**TOWN OF NEWBURGH
PLANNING BOARD**

PROJECT NAME: MID VALLEY / STARBUCKS
PROJECT NO.: 23-14
PROJECT LOCATION: SECTION 75, BLOCK 1, LOT 13.1
REVIEW DATE: 27 OCTOBER 2023
MEETING DATE: 2 NOVEMBER 2023
PROJECT REPRESENTATIVE: BOHLER ENGINEERING – STEVEN R WILSON/KIMBERLY HORN
ENGINEERING & LANDSCAPE ARCHITECTURE

TYPICAL PARKING SPACE DETAIL

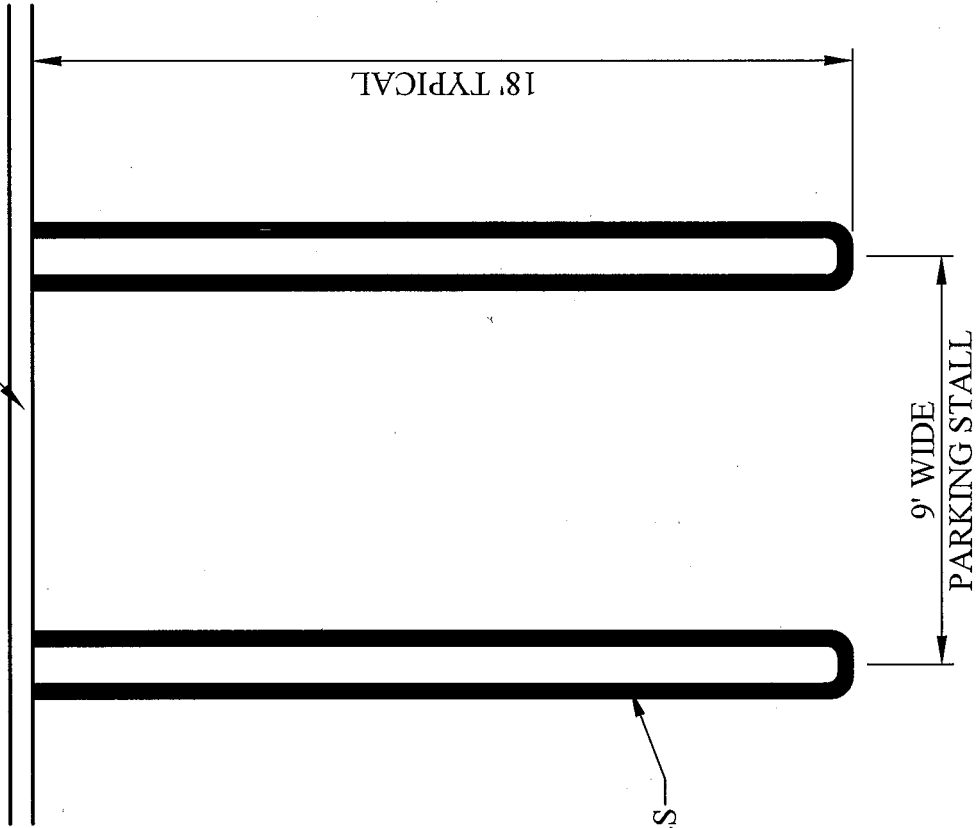
8. The proposed structure will be required to have fire suppression sprinklers. Town of Newburgh has a more stringent ordinance than the NYS Code. Town of Newburgh has a requirement that the potable water be terminated to the structure should the sprinkler supply be terminated. Schematic Detail is attached.
9. Standard Town parking space detail striping is attached.
10. Detailed design of the sanitary sewer pump station should be provided.
